Responses to Comments

The following comment letters were submitted on the initial study/proposed project during the public review period or at the public hearing. Each of these letters has been assigned a letter and each comment within the letter has been assigned a number. Therefore, individual comments have been labeled “A-1”, “A-2”, etc. Each bracketed comment is followed by the response. The complete set of bracketed letters has been included at the end of these responses.

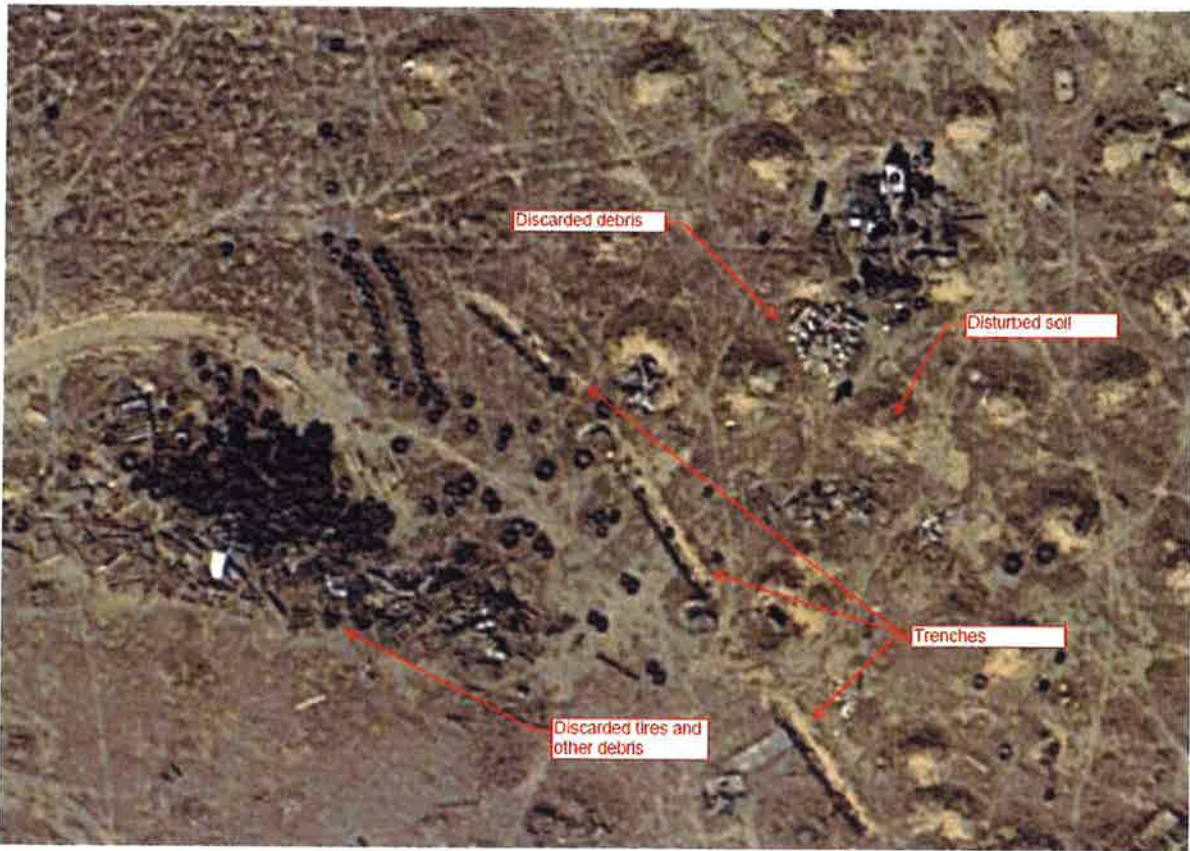
The trash and debris piles are clearly visible in aerial images on Google Earth. The images below show areas of disturbed soil, discarded tires, and debris.

The area of the Project site, east of 25th Street East (Parcel D), has been used for dumping. A 2013 Phase I Environmental Site Assessment describes the Project area as "vacant land with debris, including rubber tires" and "Trash and debris, including rubber tires, roofing shingles and discarded aluminum cans, was observed throughout the Property."¹

The trash and debris piles are clearly visible in aerial images on Google Earth. The images below show areas of disturbed soil, discarded tires, and debris

The area east of 25th Street East is devoid of vegetation and debris. The area that the commenter refers to as containing rubber tires, shingles, trash and debris is located west of 25th Street East, close to the western property line. Staff agrees that the aerial images clearly show areas of discarded tires and that this area needs to be cleaned up in accordance with all existing rules and regulations. However, no evidence has been submitted that the dumping has been going on for over 10 years or that petroleum compounds have been dumped. The Phase I Report found no evidence of soil staining or discarded petroleum compound containers.
